## **Proposal of amendments to ECE/TRANS/WP.29/2010/127 (Draft Regulation on pedestrian safety)**

### **Test area and Measuring point**

Figure 7A

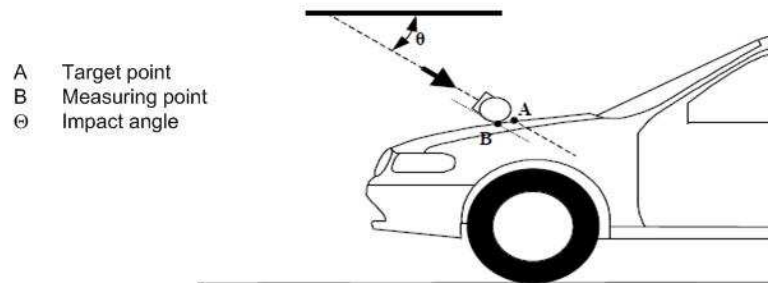
Delete old figure 7 and add new Figures 7A, 7B and 7C, as follows:

“2.29. “Target point” means the intersection of the projection of the headform longitudinal axis with the front surface of the vehicle (see point A in Figure 7A).

“2.41. **The measuring point for the headform test is a point in the vertical longitudinal plane of the vehicle, containing the centre of the impactor. In this plane, it is the point at which the impactor nominally first contacts the bonnet top (see point B in Figure 7A and 7B). The first contact point may differ from the measuring point as a result of the geometry of the bonnet top.**”

Figure 7B

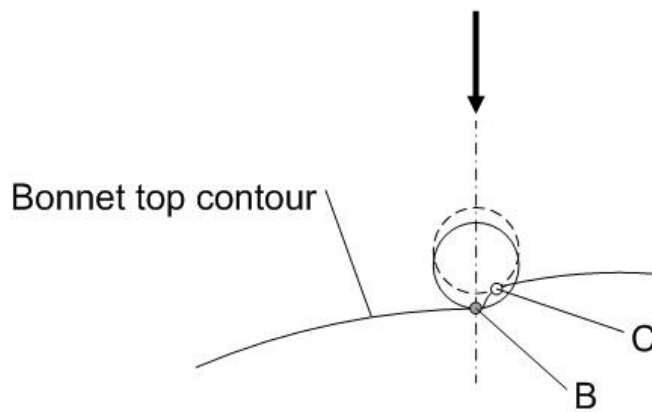
“2.22. ~~Impact~~ **First contact point**” means the point on the vehicle where initial contact by the test impactor occurs. The proximity of this point to the target point is dependent upon both the angle of travel by the test impactor and the contour of the vehicle surface (see point **C B** in Figure 7B and Figure 7C).”

**Remark:** Due to the spatial geometry of the bonnet top, the first contact point C does, in most cases, not lie in the same vertical longitudinal or transverse plane which contains measuring point B.
